It has been found that, in a few cases, film error rates become rather high as a result of very low film tension at the entrance to the DSTR.

SOLUTION: Increase the film tension within the closed loop.

Figure 2

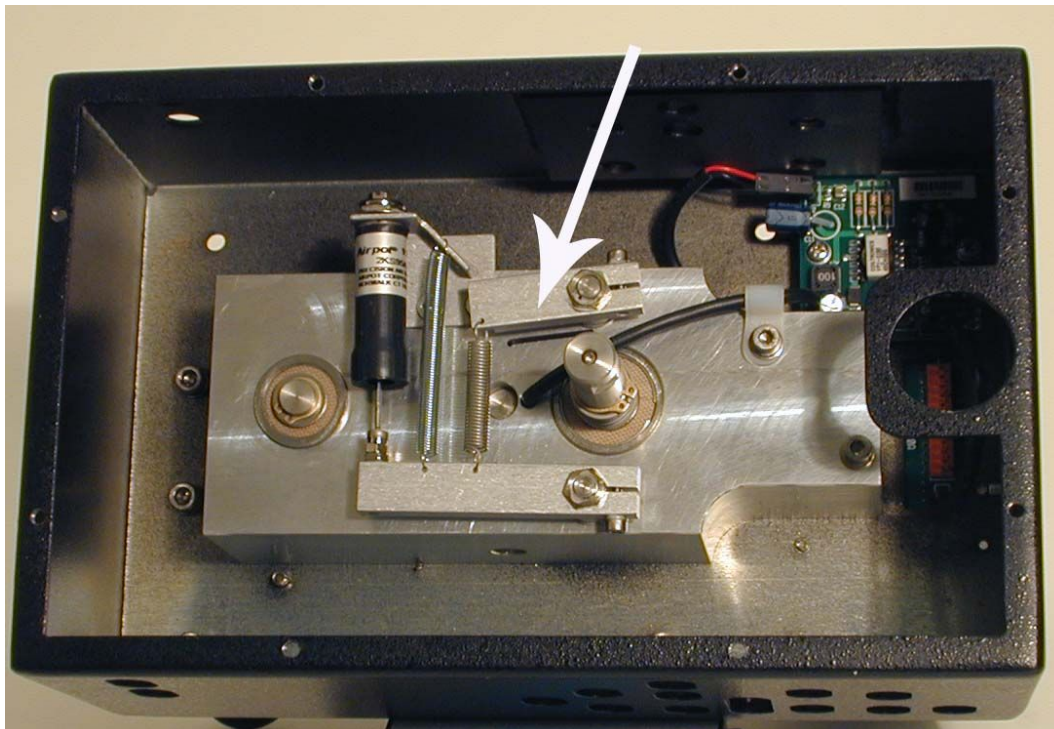
Referring to figure two, draw a pencil line along the edge of the idler arm as shown.

Figure 3

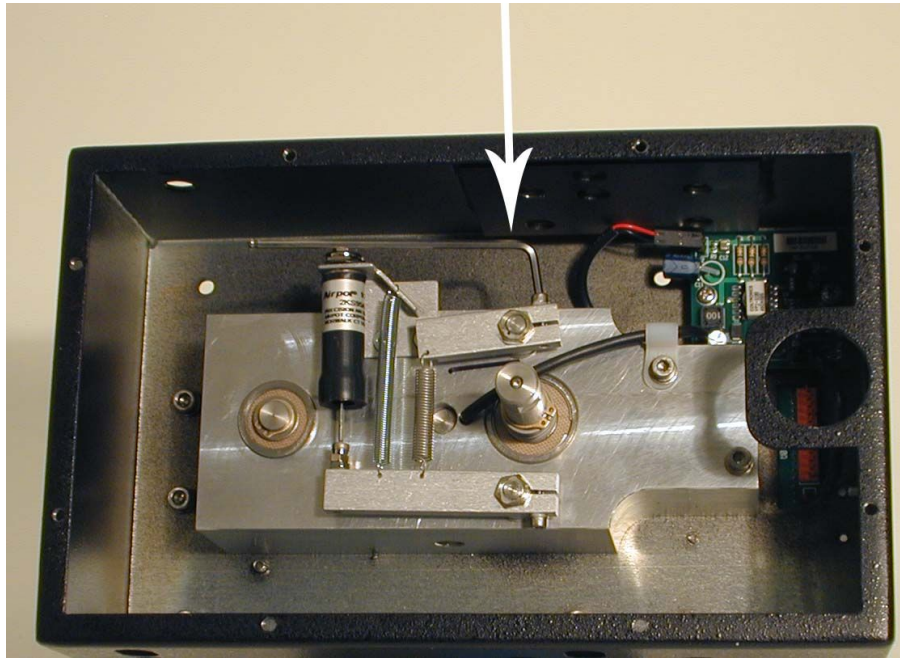
Refer to figure three.

Loosen indicated locking screw with a 2.5mm Allen Wrench.

Rotate idler arm clockwise and hold it at a position so that there is approximately 1/8th of an inch of space between the pencil mark and the arm.

Figure 4

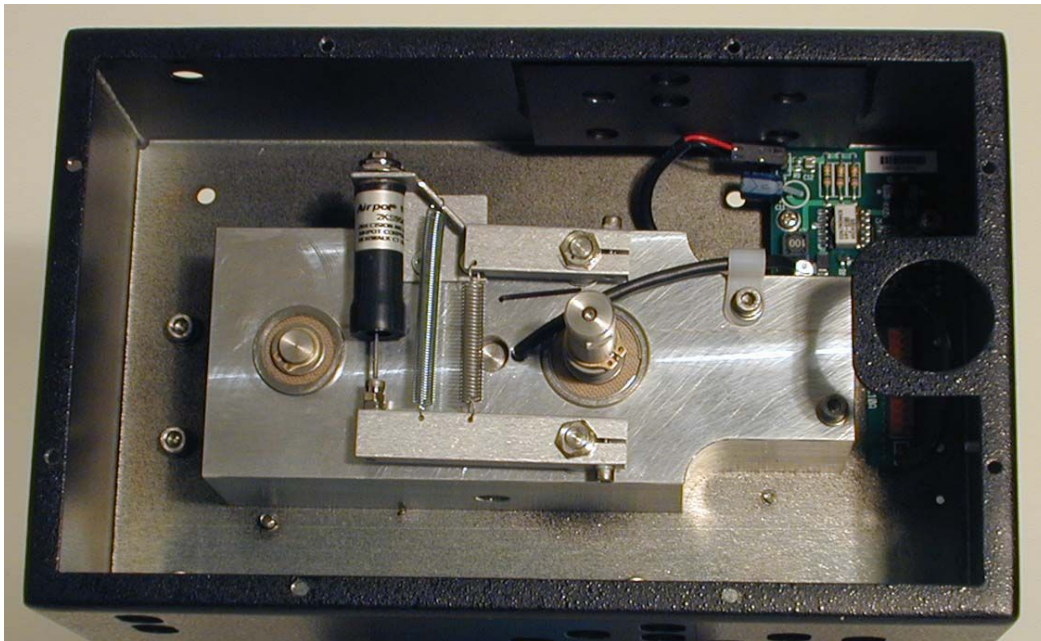
Refer to figure four

Tighten the locking screw.

The film loop tension has now been increased by approximately 10%.
